EDC IN-LINE PUMPS
WITH RE-POSITIONER

Workshop: EP
09.1995
SI 0498 En

New rack and modified assembly
sequence for RE-positioner with
"high oil level"

KMK06167

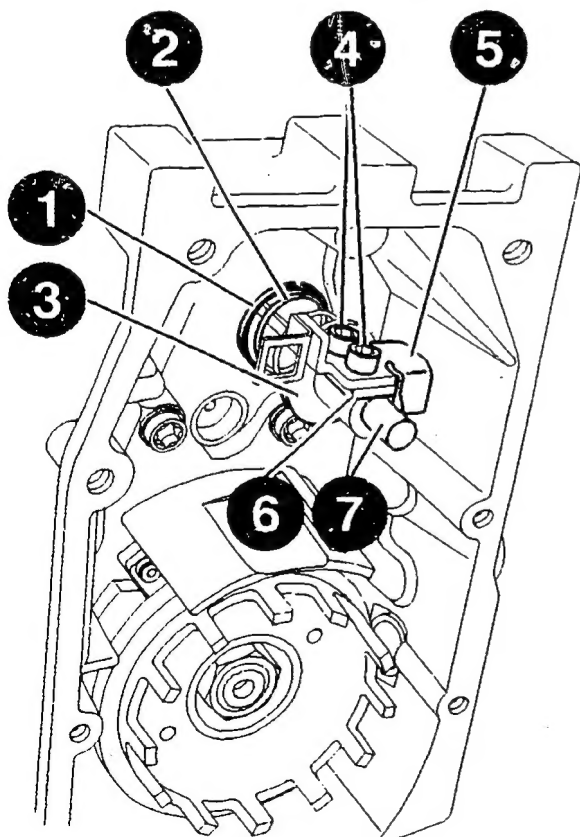
Discontinuation of the rack seal permitted standardization of rack and bearing with the versions used in mechanically governed injection pumps, i.e. rack guide bushing on either side, positioner-end bushing pressed in and fixed by a threaded sleeve.

The holder for the RPS short-circuiting ring and the thrust piece for the injected-quantity solenoid are bolted to the rack with two micro-encapsulated M5 bolts.

- * Before removing the rack, screw out the two screws and remove holder for short-circuiting ring, thrust piece, spring seat and spring.
- * On assembly: Remove residual micro-encapsulation from threads of both fastening screws and from tapped holes in thrust piece.

- * Coat threads of both fastening screws with locking compound "Loctite 242".

After inserting spring and spring seat, mount holder for short-circuiting ring and thrust piece on rack. Tighten screws to 4.0...5.0 Nm.

KMK07656

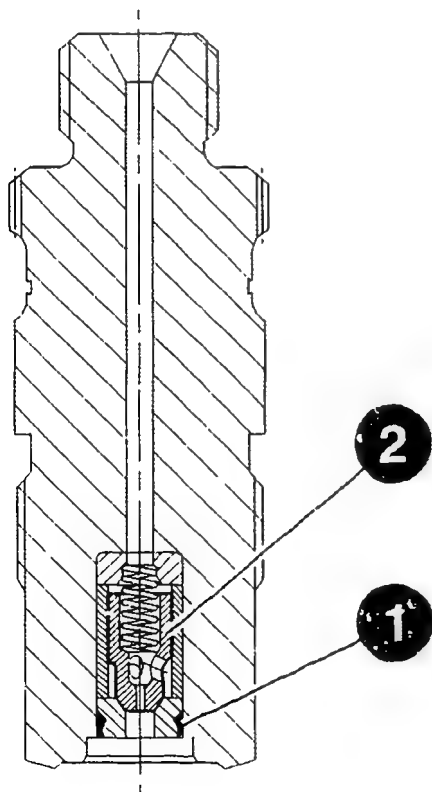
As a result of manufacturing modifications to the delivery-valve holder with non-return flow control valve (RDV), failures may be encountered in engine operation due to the destruction of rivet joints (1) or loose valve holders (2).

For this reason, the delivery-valve holders with RDV concerned must be replaced by new ones.

KMK09167

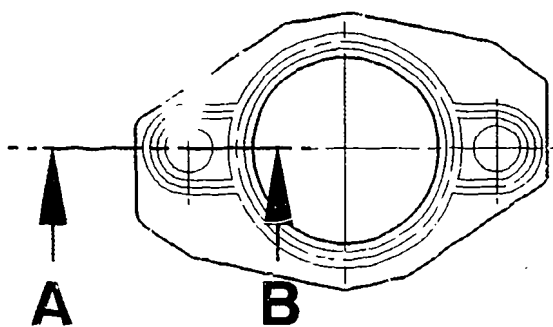
- 4-hole mount for timing device cover with sealing plate (Fig.)
(does not affect Ford-VE..F)
- Central screw plug with modified sealing surface
